ADDENDUM NO. 2
The Jefferson Project Sculpture Park and Garden

THE JEFFERSON PROJECT
 1113 N JEFFERSON
 BAY CITY, MI 48708

SHEET
C-3.0

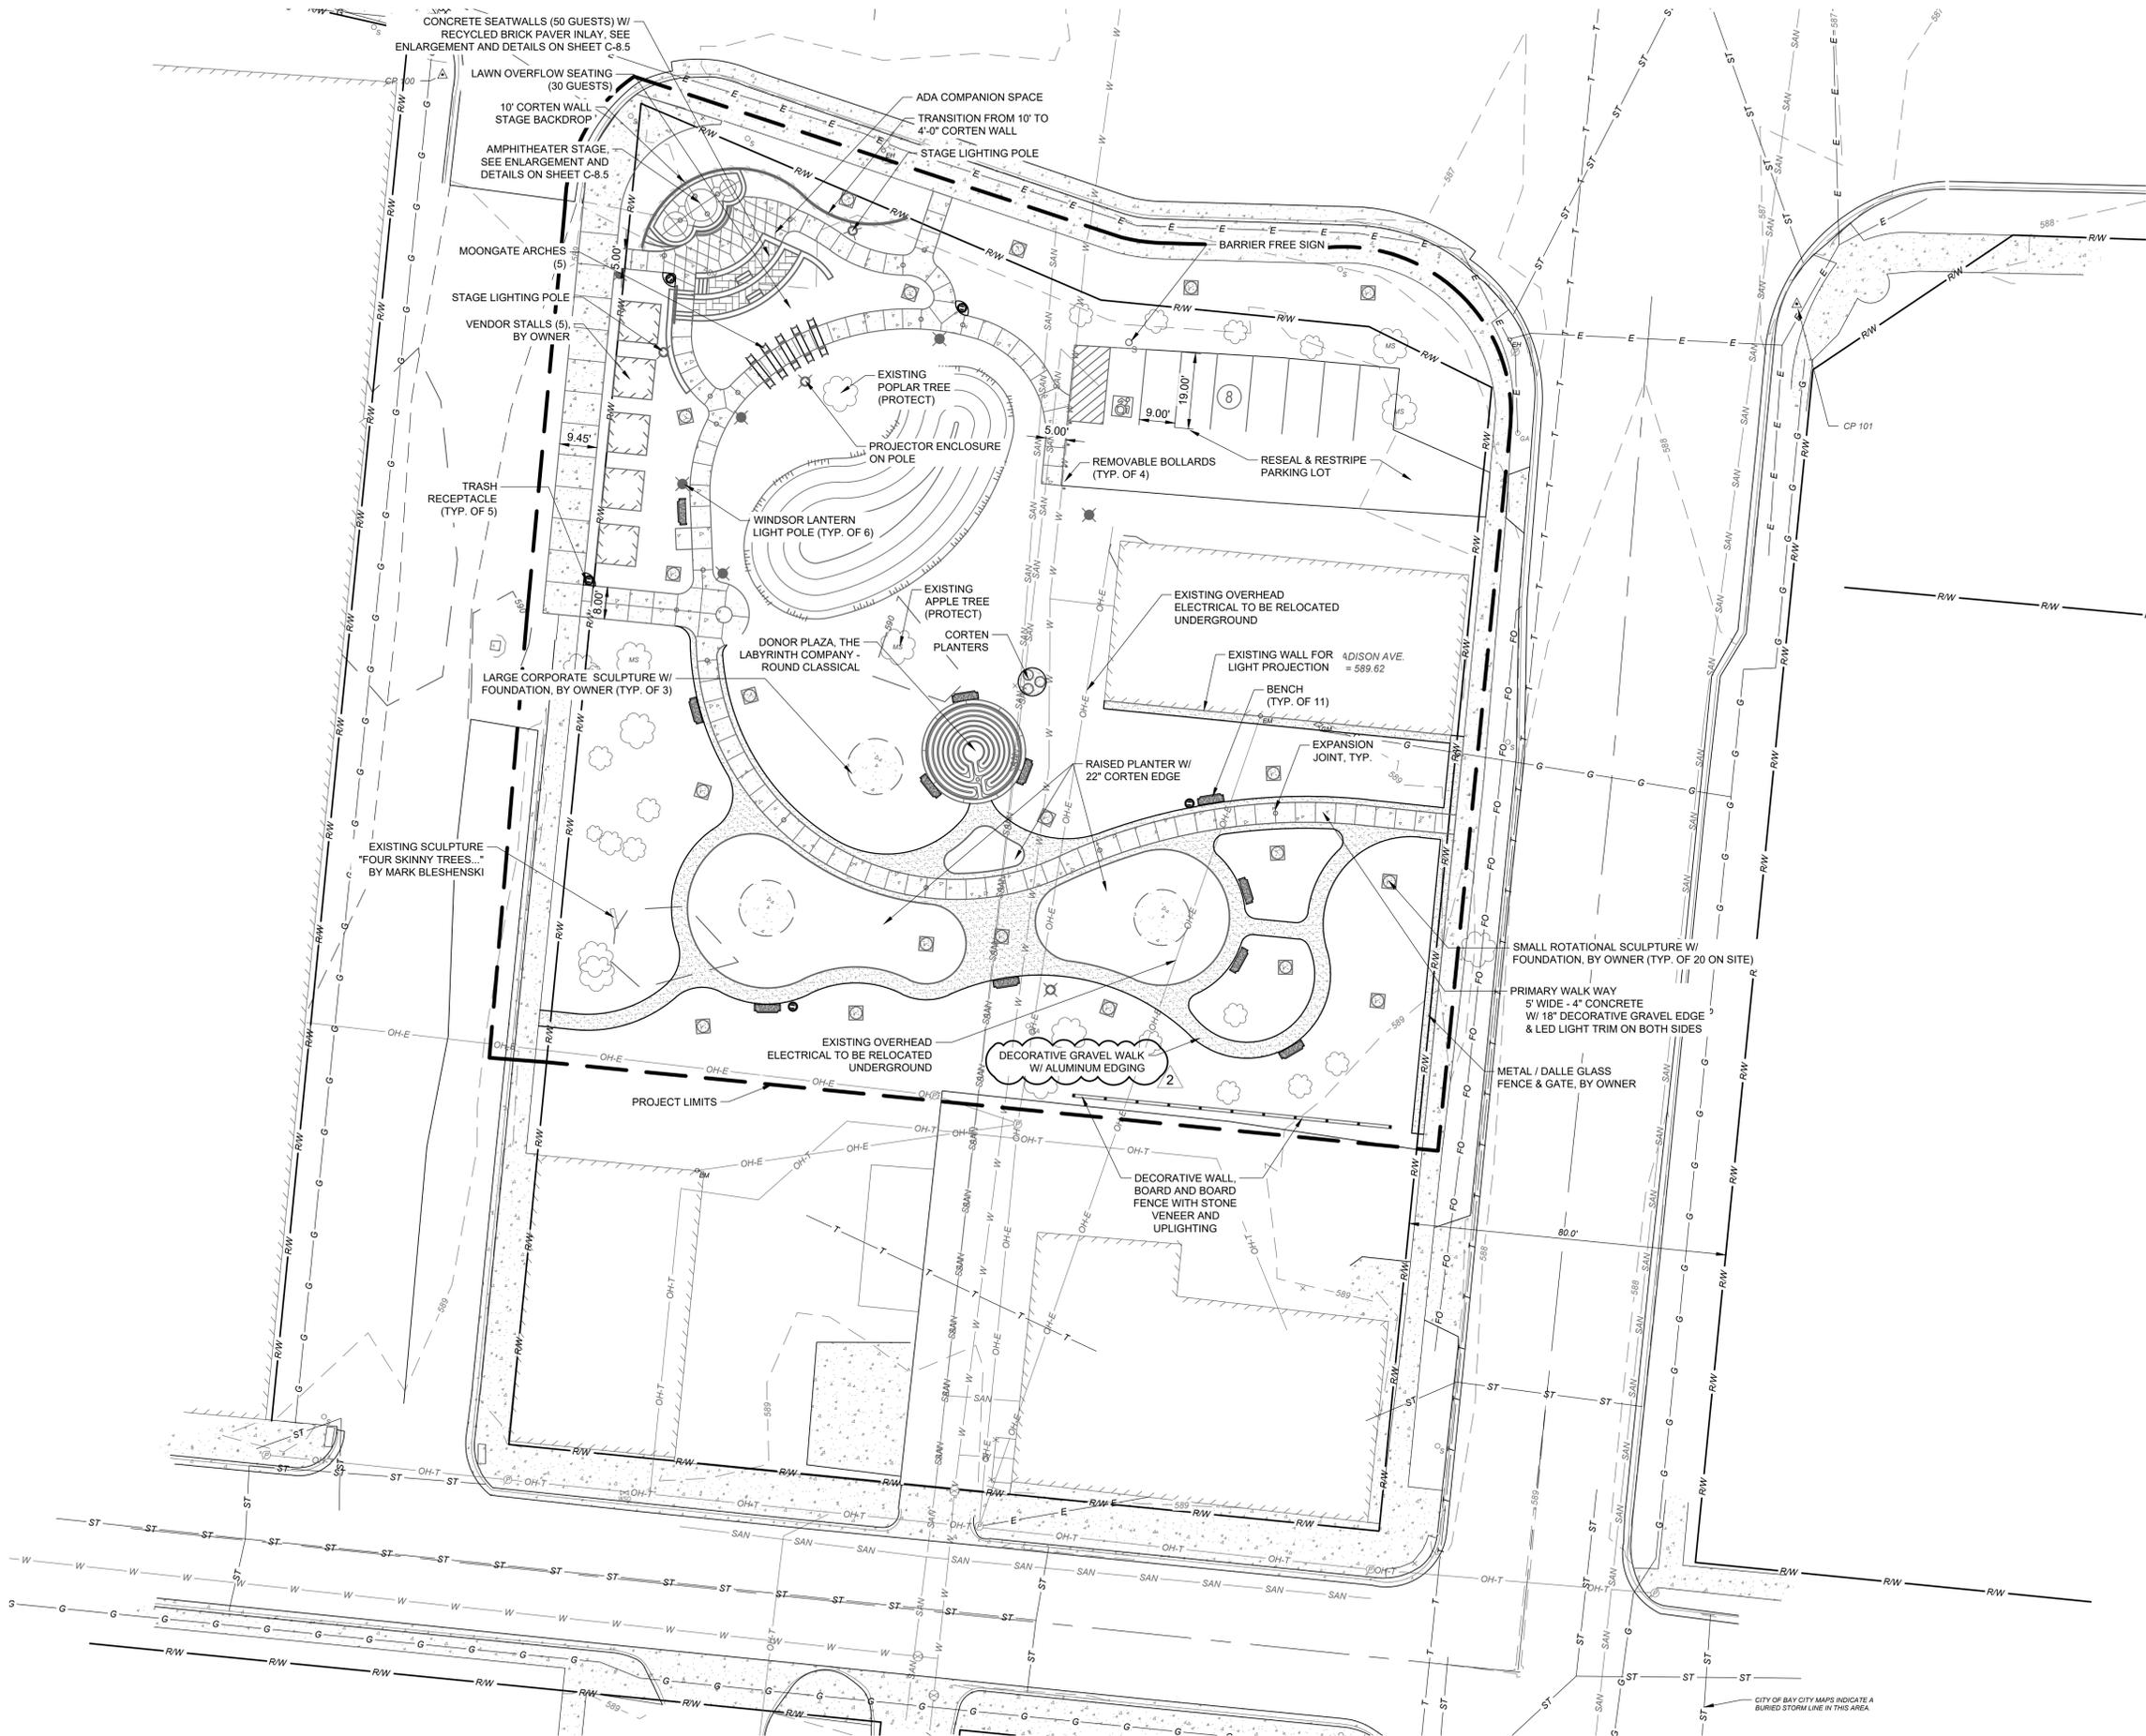
Page	Description of Change
Plan Sheet G-1.0	Landscape Edging Plan L-1.2 added to sheet index
Plan Sheet C-3.0	Proposed 6" corten edging deleted from plan and replaced with aluminum edging
Plan Sheet L-1.0	Added mulch bed around Moongate arches
Plan Sheet L-1.2	Sheet added for clarification of landscape bed and gravel walkway edging. All edging will be Clean Line Commercial Grade Aluminum Landscape Edging.
Plan Sheet L-2.0	Corten edging detail removed and Aluminum detail added for all edging
Plan Sheet C-8.0	Aluminum edging added to detail for location and install clarification
Plan Sheet C-8.0	Crushed limestone reduced from $\frac{1}{2}$ " to $\frac{3}{8}$ "
Plan Sheet C-8.0	Stabilizer note added for crushed limestone surface
Plan Sheet C-8.1	Crushed Limestone Path with Metal Edging detail added for clarification

2. Q - CORTEN for the walks, and steel for other beds? The attached image shows some highlighted areas I need clarification about. Along the sidewalk to the east, and along the south side of the building.

A - All edging has been changed to Aluminum. See description of change in table above.
